November 24, 2021

Subject: George Hall Elementary School HVAC Replacement
San Mateo - Foster City School District
Aedis Project No. 2021005.02
DSA Application #01-119523

ADDENDUM NO. 1

**AD1-
A1.02**

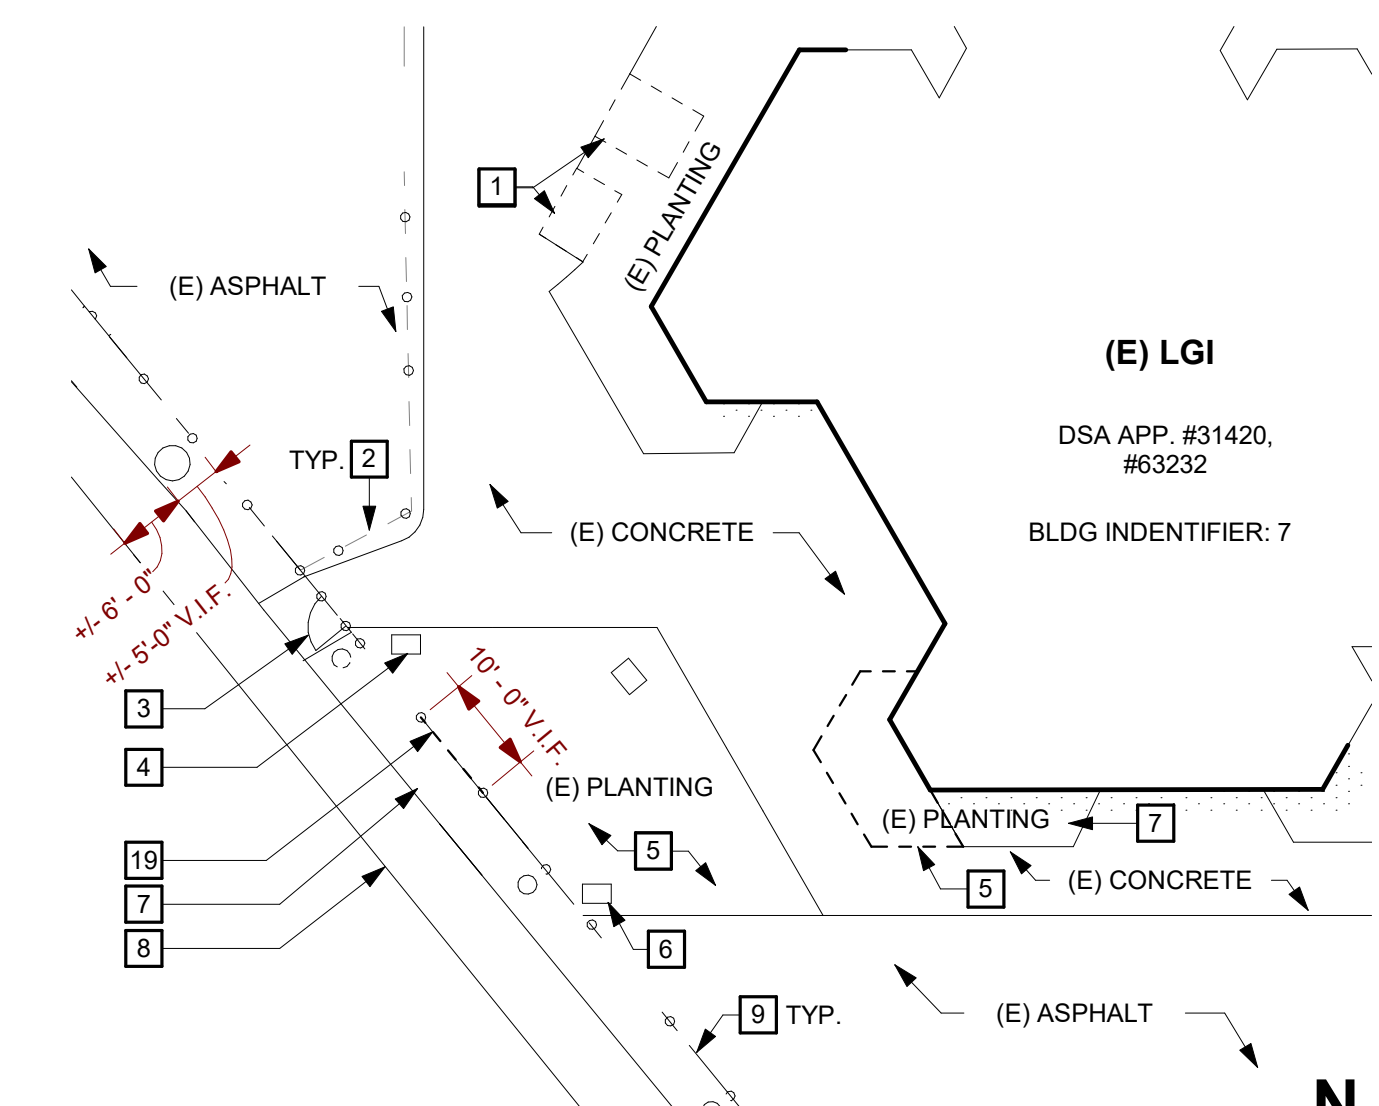
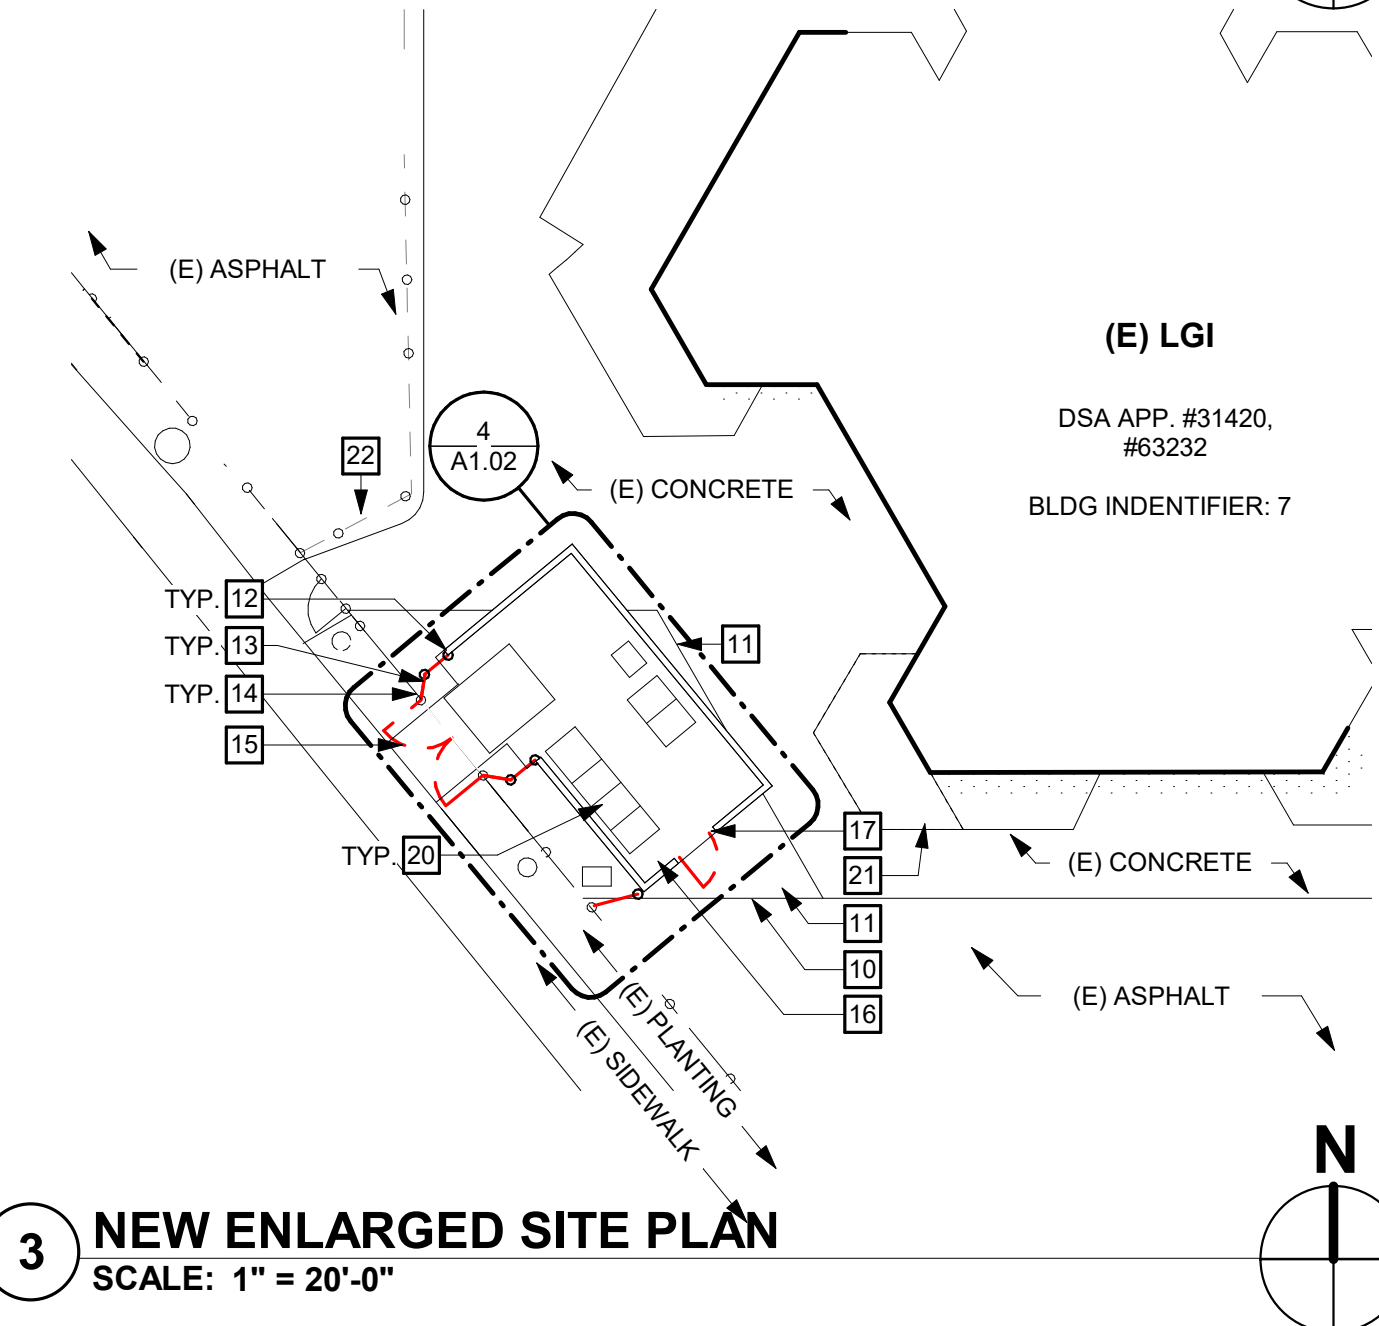
Add: Trench area to New Site Plan 1/A1.02 & Graphic Key per AD1-A1.02

Add: General Sheet Note item G per AD1-A1.02

Add: Striping keynote 25 to New Site Plan 1/A1.02 per AD1-A1.02

SHEET # AD1-
A2.01

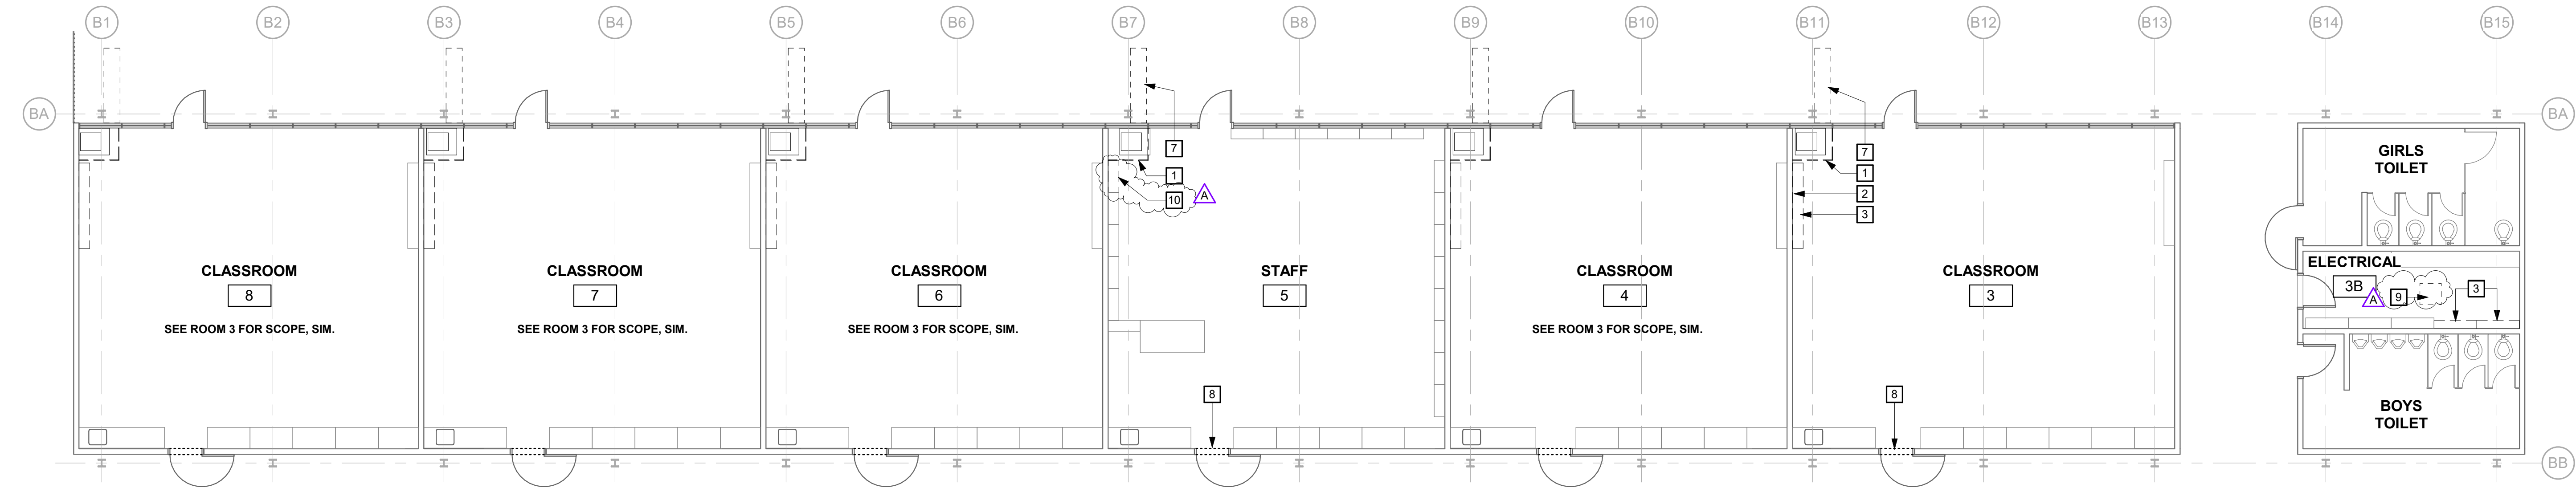
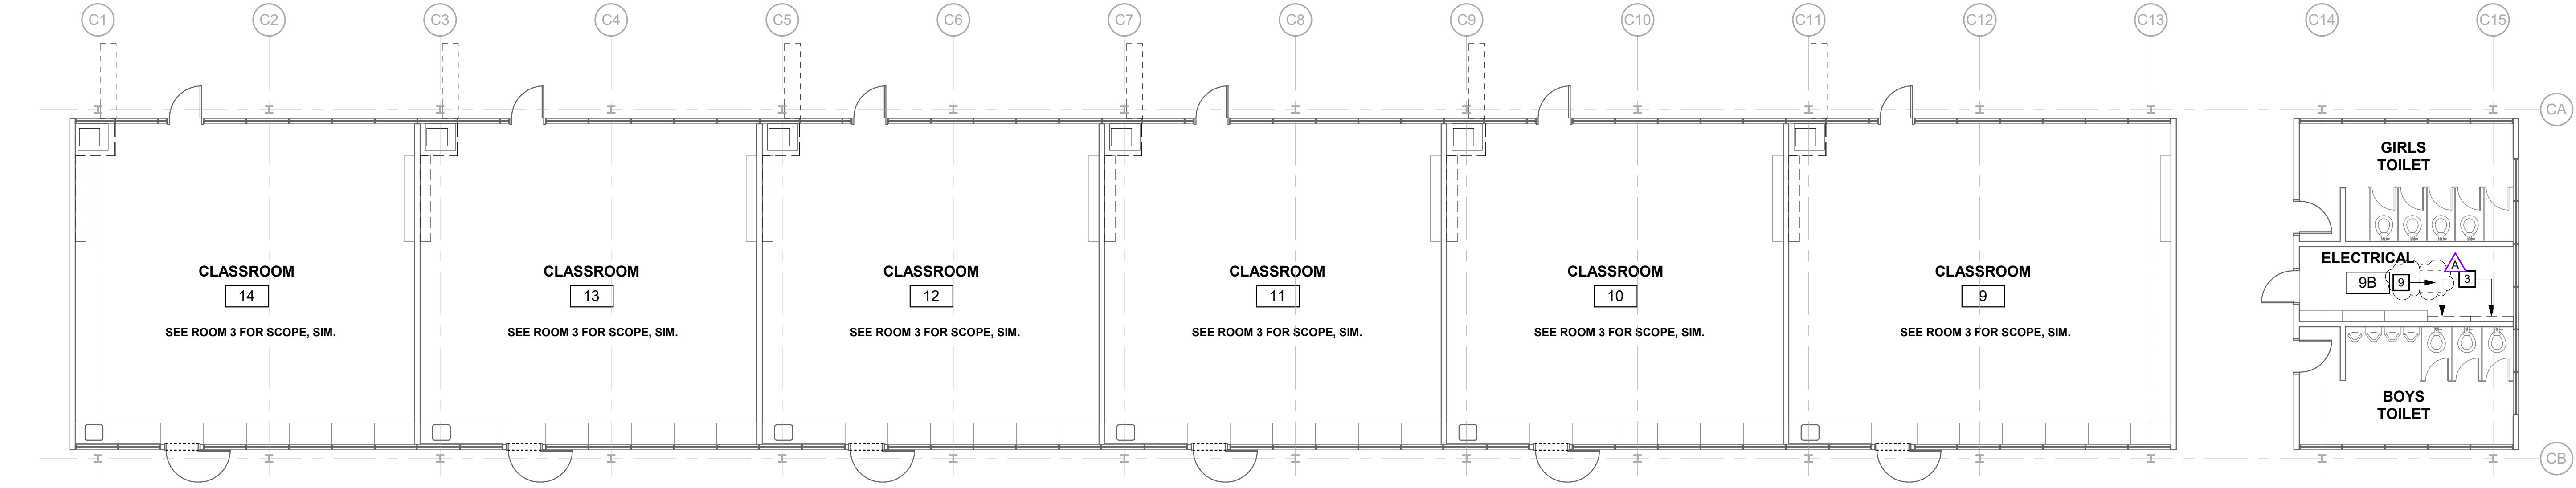
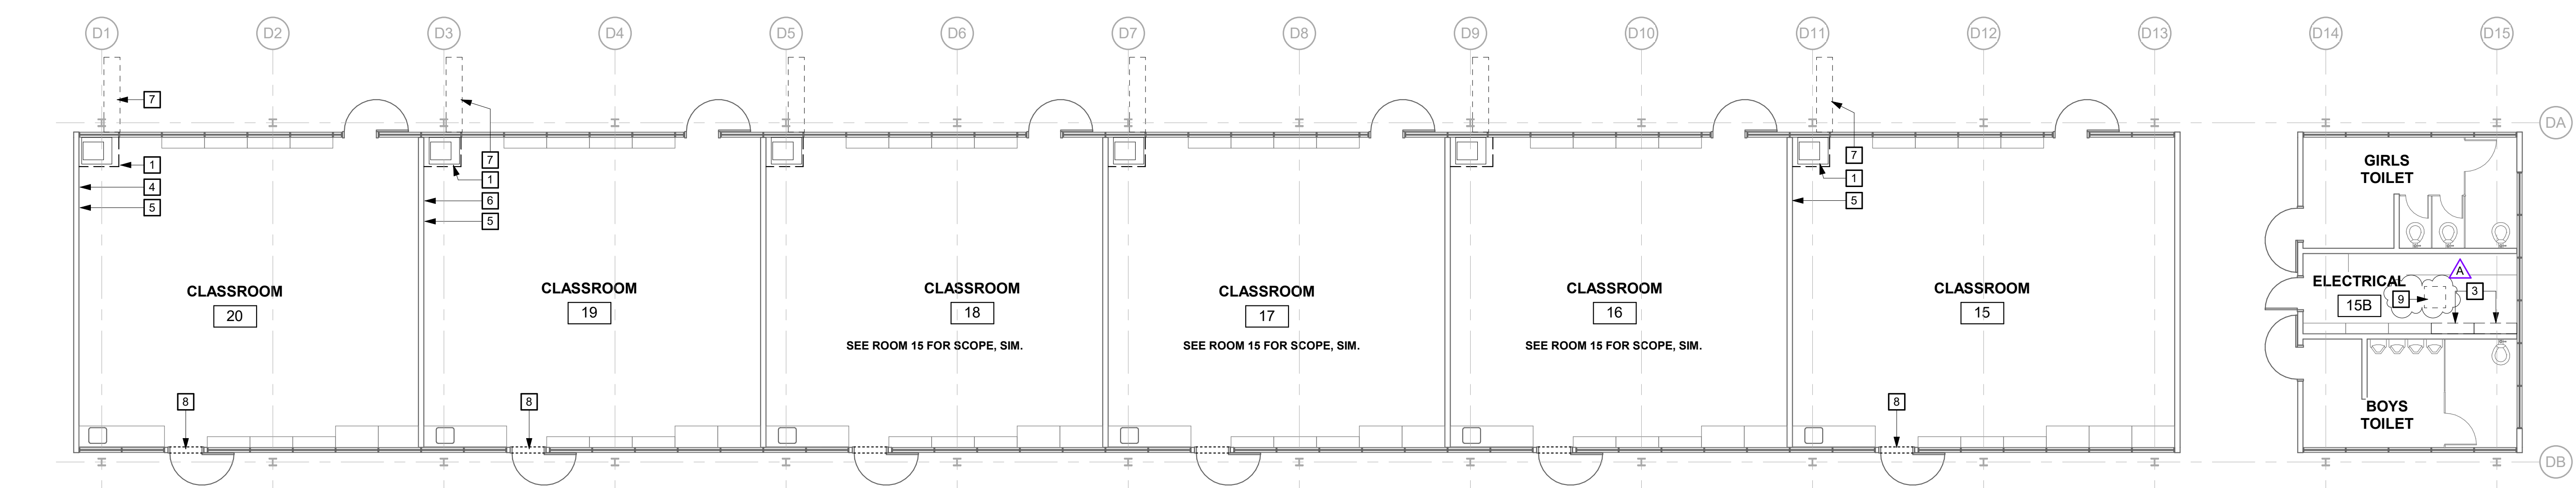
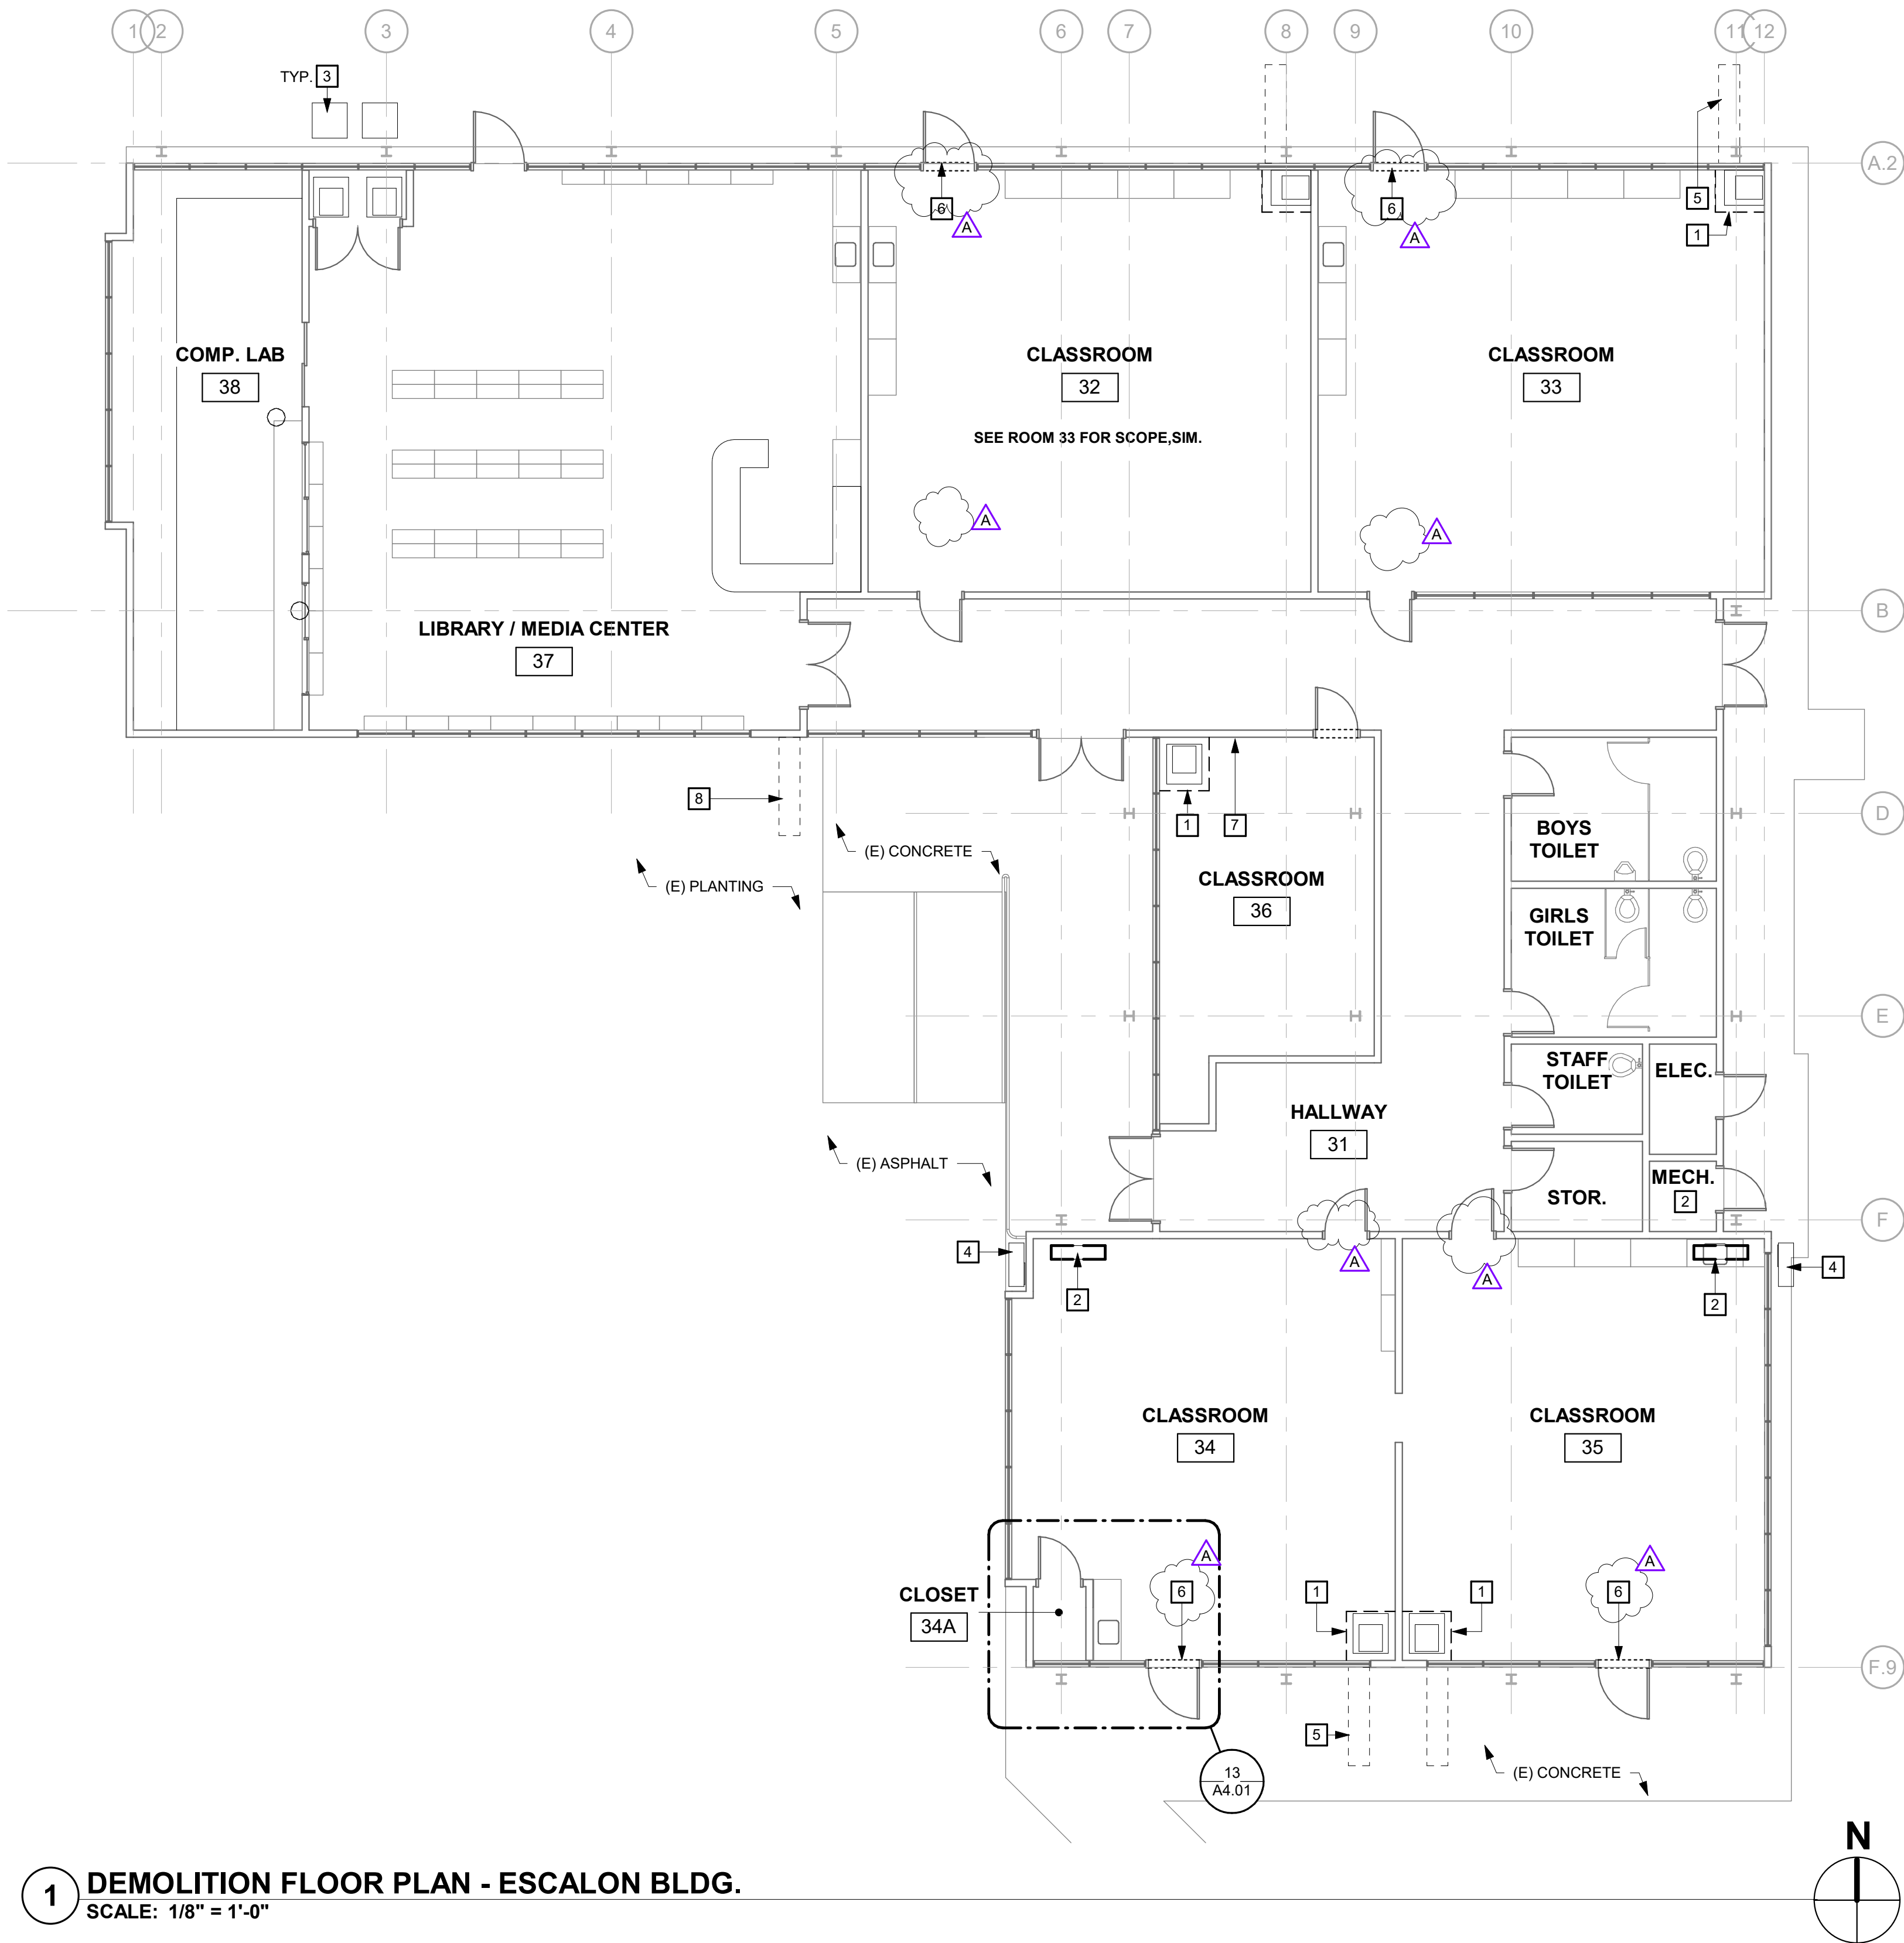
Add: General Sheet Note #J per AD1-A2.01

Add: Demolition Floor plan Keynotes #9 & #10 per AD1-A2.01

Add: Partial ceiling demolition keynote #9 at Demolition Floor Plans 2/A2.01, 3/A2.01, and 4/A2.01 per AD1-A2.01

Revise: At Classroom 5 replace keynote 2 with keynote 10 per AD1-A2.01
